PLANT HATCH - UNITS 1, 2  
NRC DOCKETS 50-321, 50-366  
OPERATING LICENSES DPR-57, NPF-5  
ADDITIONAL INFORMATION REGARDING  
IMPLEMENTATION OF 10 CFR 50.62 (ATWS RULE)

PLANT HATCH - UNITS 1, 2  
MRC DOCKETS 50-321, 50-366  
OPERATING LICENSES DPR-57, NPF-5  
ADDITIONAL INFORMATION REGARDING  
IMPLEMENTATION OF 10 CFR 50.62 (ATWS RULE)

Schematic depicting isolation of ARI from ATTS

FIGURE 1

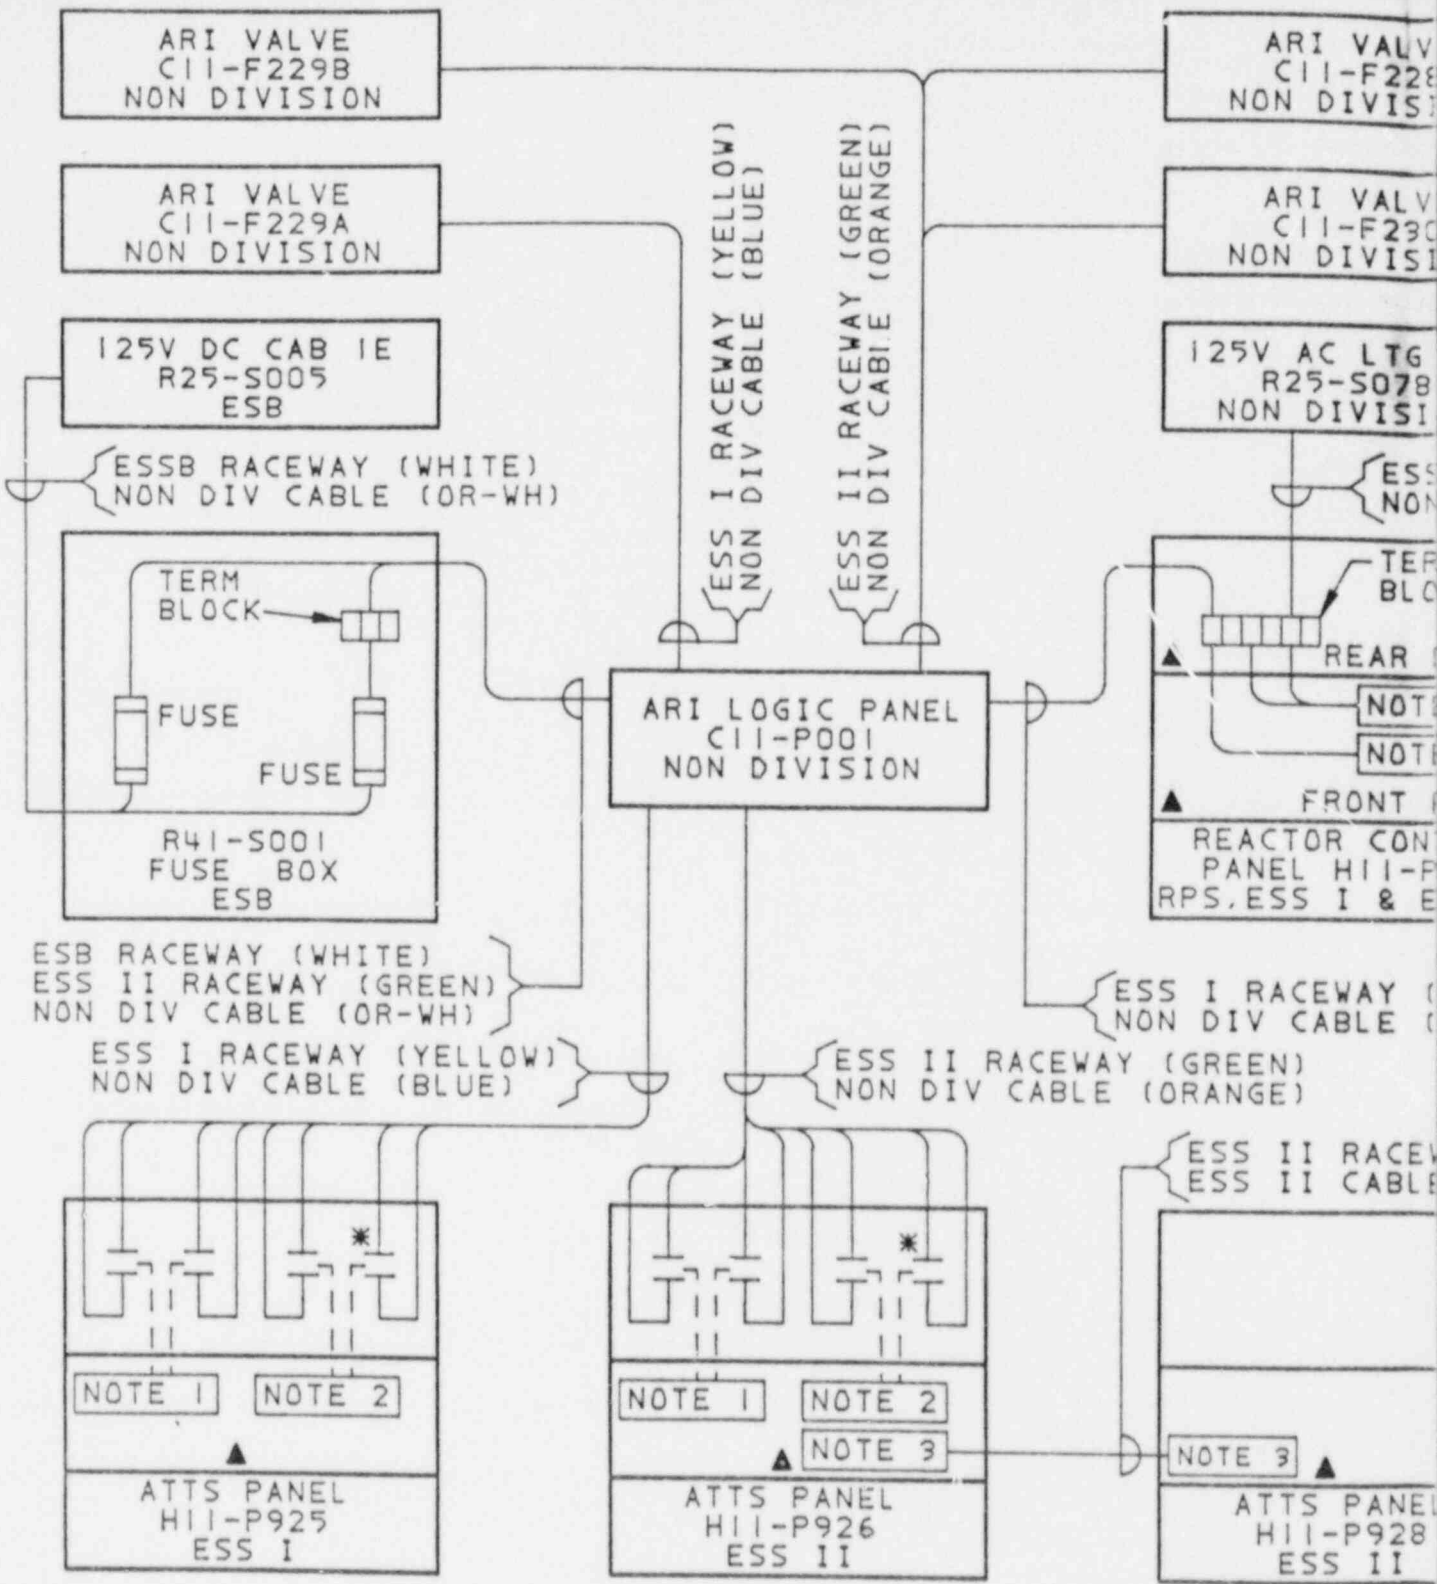
NRC Item 2: Describe the devices which isolate the ARI from the ATTS (identified as trip relays in your submittal).

GPC Response: The relays identified as trip relays in GPC's report are Agastat relays located in the non Class 1E sections of Analog Transmitter Trip System (ATTS) panels. These relays were originally installed as spares during ATTS implementation. A schematic depicting the subject relays is provided as Figure 1.
